California Ridge Wind Farm Champaign County, IL

Natural Resource Report

October 6, 2011

California Ridge Wind Farm Natural Resource Report Summary

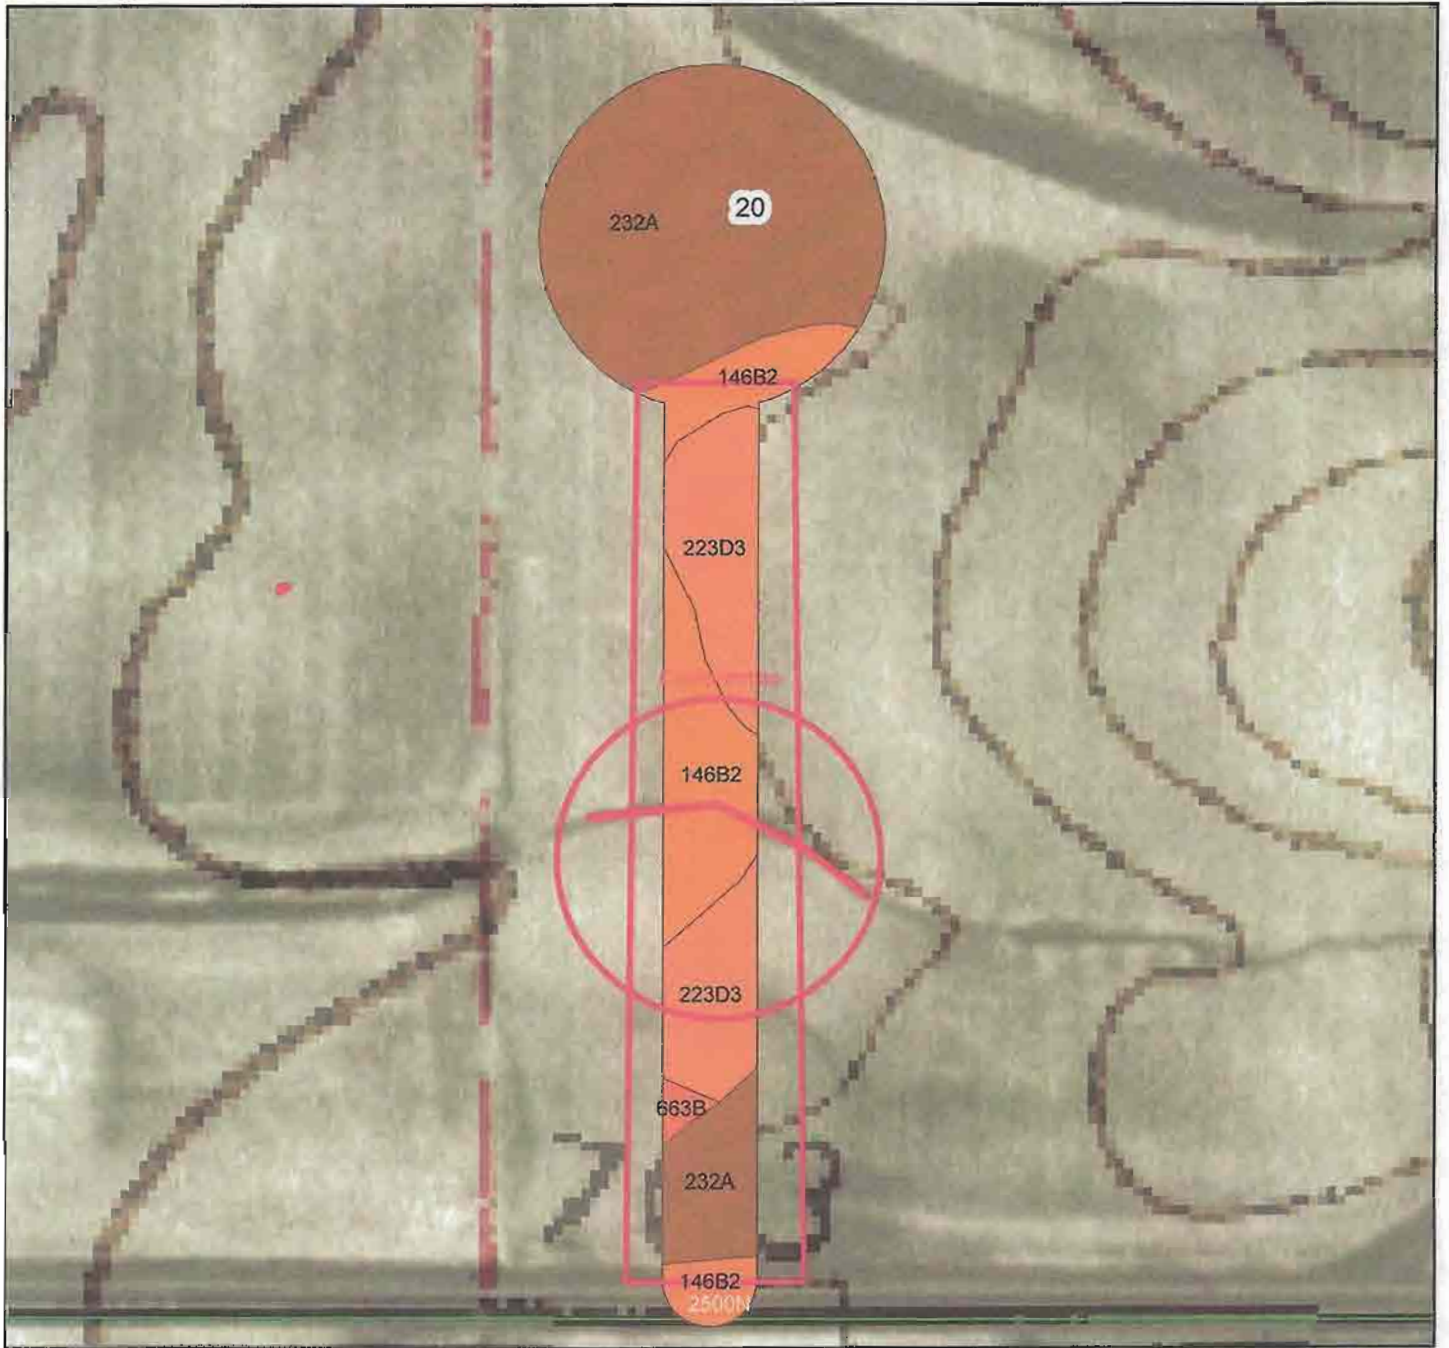
The 146B2 (Elliott Silty Clay Loam) soil has a 2-4% slope that could be an issue with water flowing over the access road possibly causing erosion of the road surface or depositing silt on the access road.

The 223D3 (Varna Silt Loam) soil has significant slopes that could be an issue with water flowing over the access road possibly causing erosion of the road surface or depositing silt on the access road and turbine parking area.

The area most susceptible is outlined in a red rectangle.

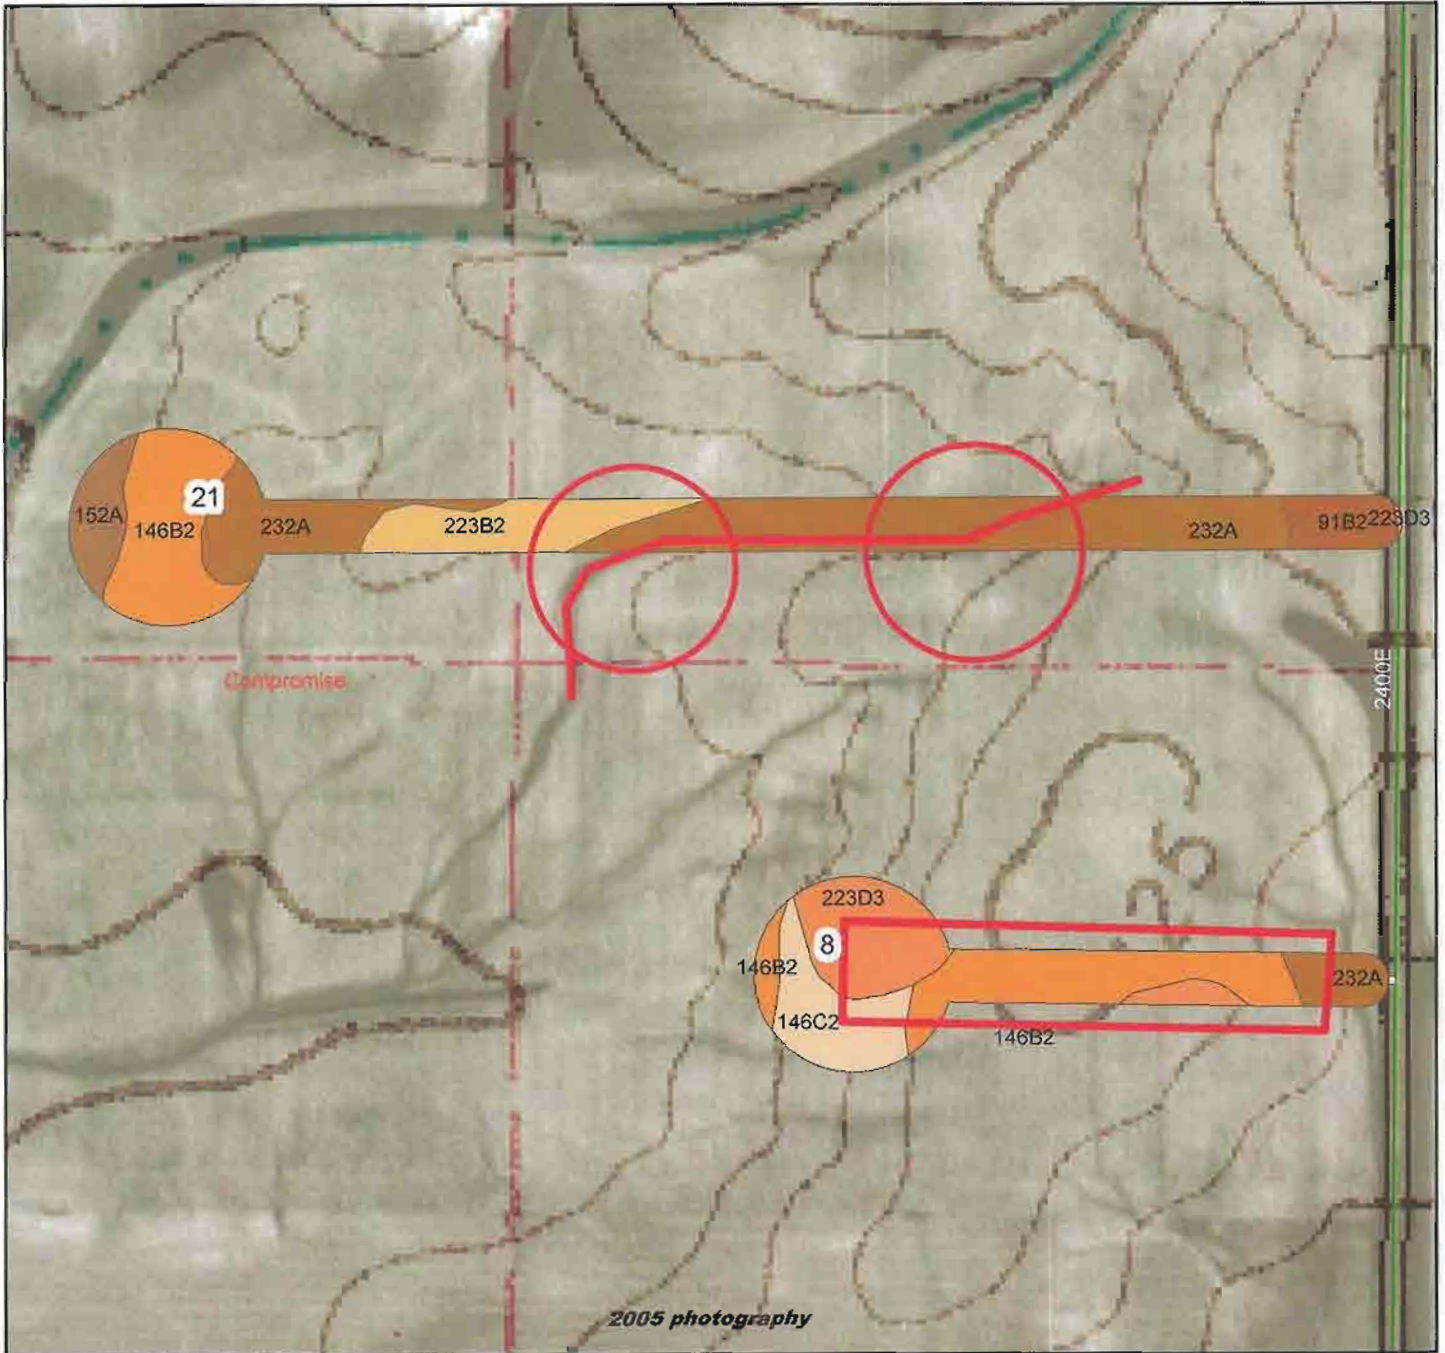
The 146B2 (Elliott Silty Clay Loam) soil has a 2-4% slope that could be an issue with water flowing over the turbine parking area possibly causing erosion of the parking surface or depositing silt on it. This is a small area near the tower that is relatively small and not be an issue.

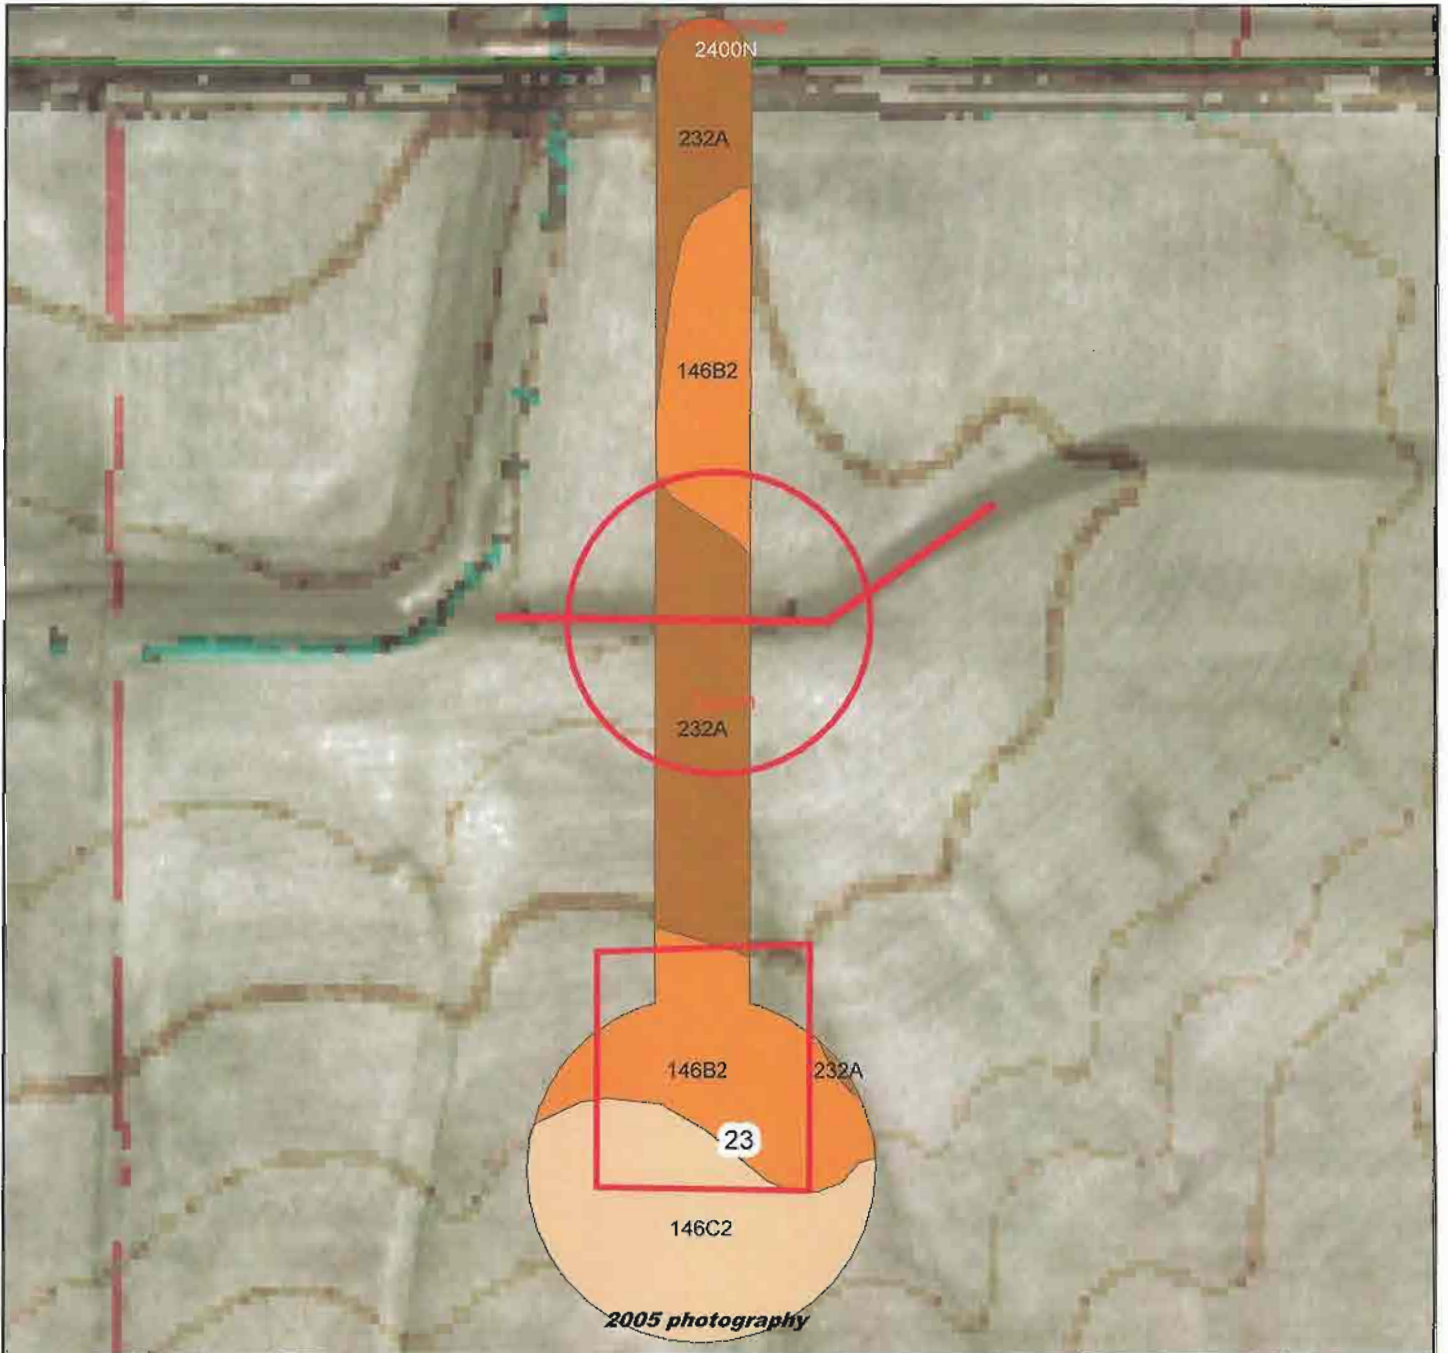
The 146B2 (Elliott Silty Clay Loam) soil has a 2-4% slope and 146C2 has 4-6% slopes that could be an issue with water flowing over the access road possibly causing erosion of the road surface or depositing silt on the access road and turbine parking area. This is a relatively limited area that may not become an issue. The area most susceptible is outlined in a red rectangle.

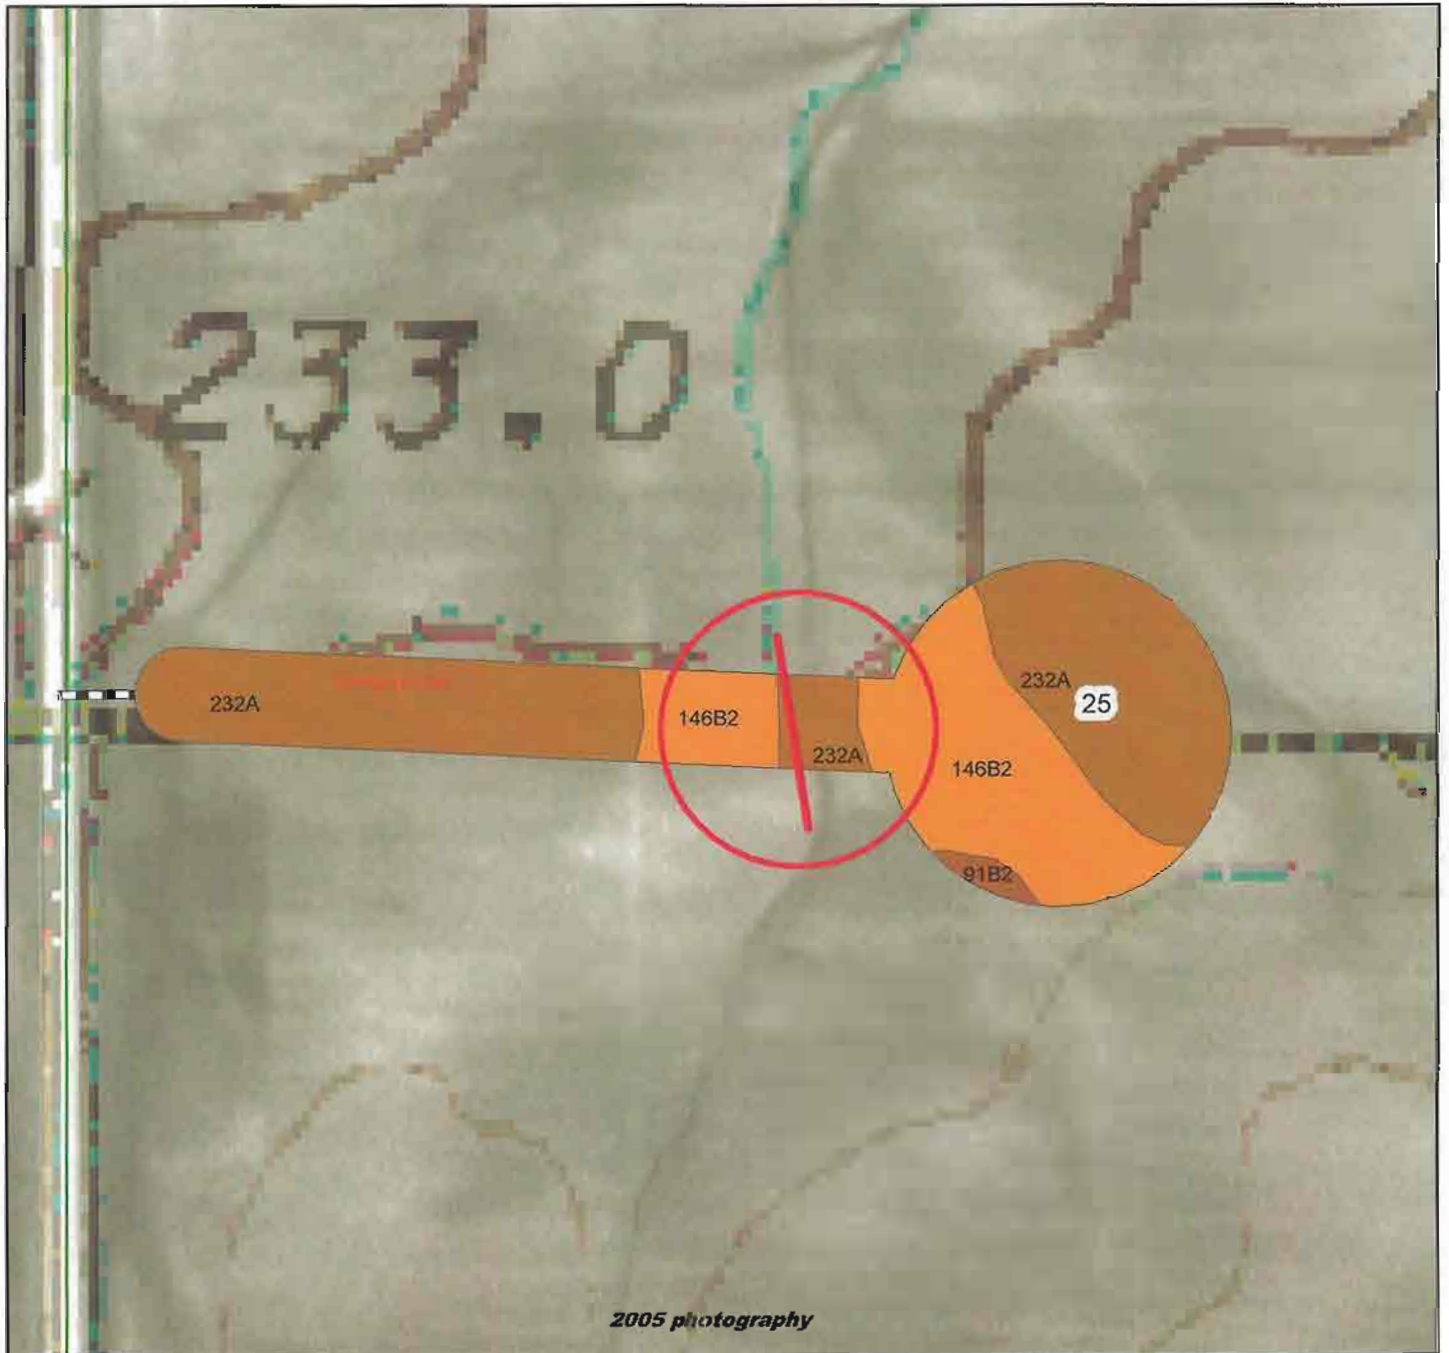
The 146B2 (Elliott Silty Clay Loam) soil has a 2-4% slope that could be an issue with water flowing over the access road possibly causing erosion of the road surface or depositing silt on the access road and turbine parking area. These areas are limited in size and may not develop into a problem.

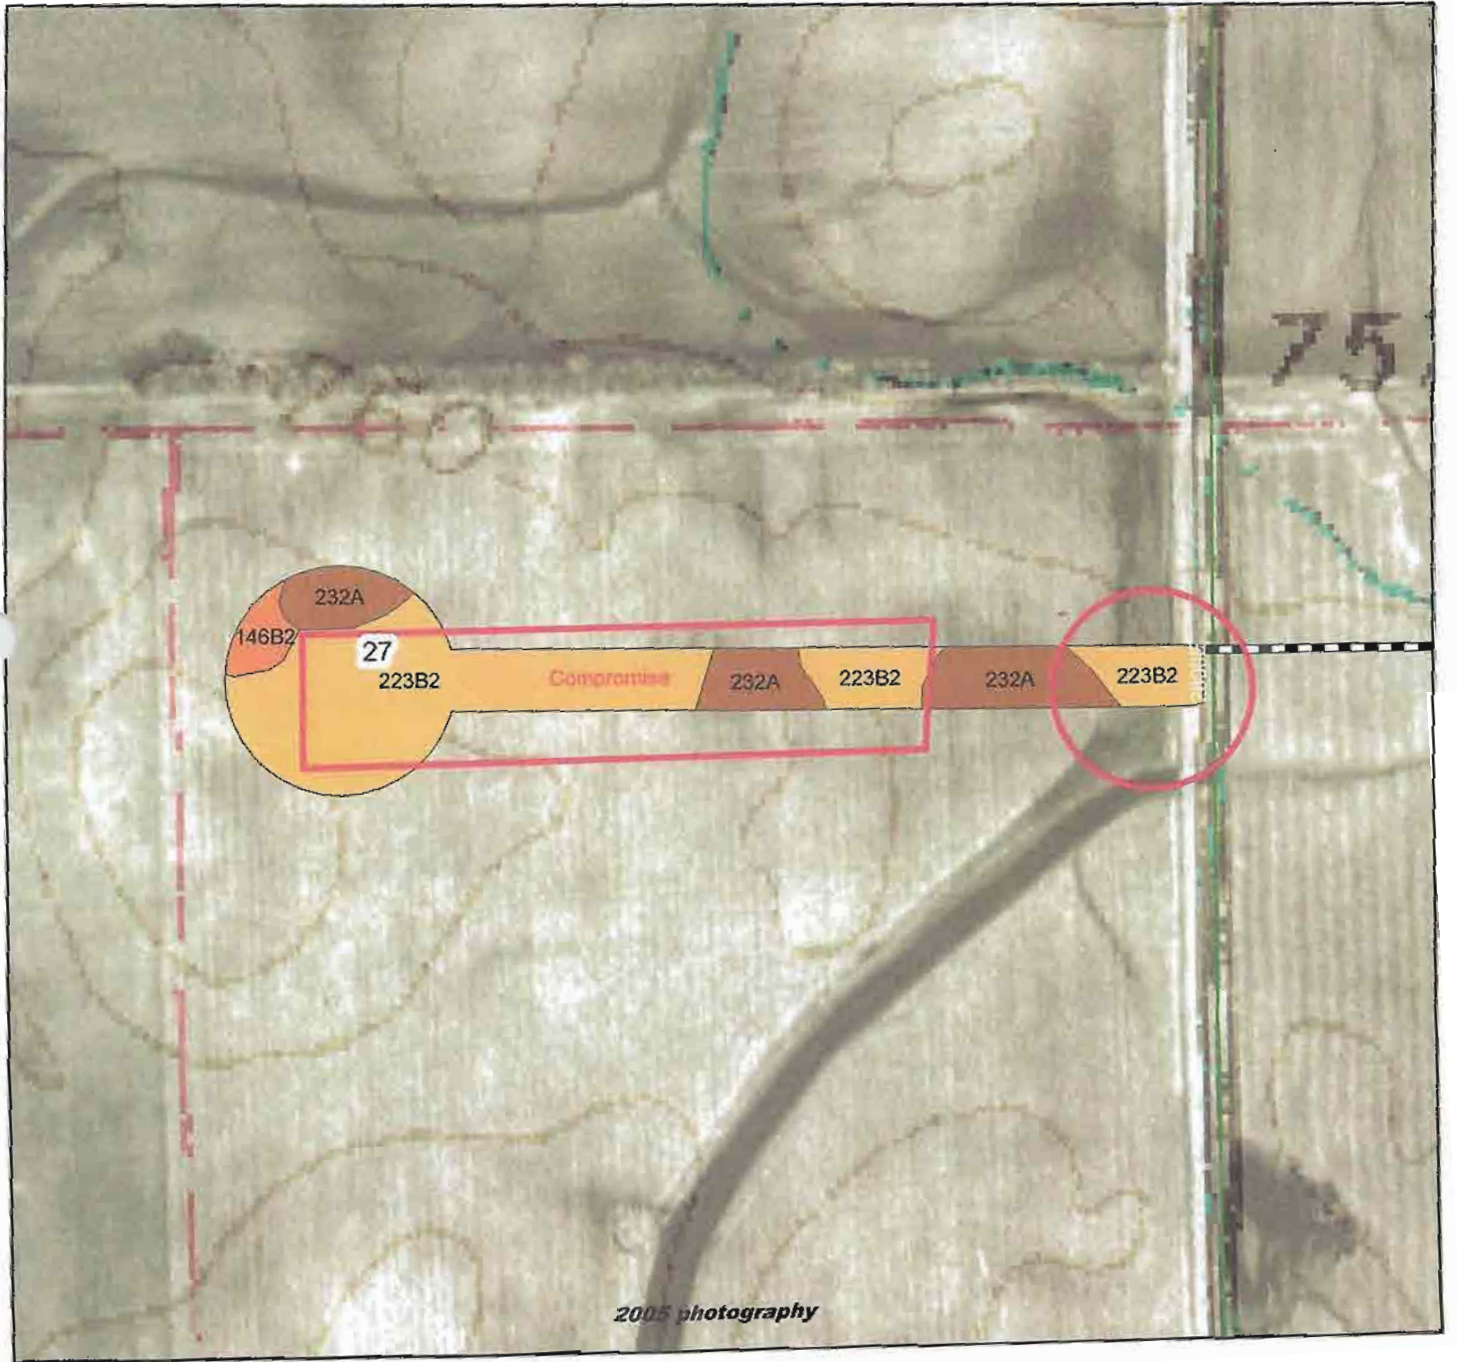
The 146B2 (Elliott Silty Clay Loam) soil has a 2-4% slope that could be an issue with water flowing over the access road possibly causing erosion of the road surface or depositing silt on the access road.

The 223B2 (Varna Silt Loam) soil has 2-4% slopes that could be an issue with water flowing over the access road and turbine parking area possibly causing erosion of the road surface or depositing silt on the access road and turbine parking area.

The area most susceptible is outlined in a red rectangle.
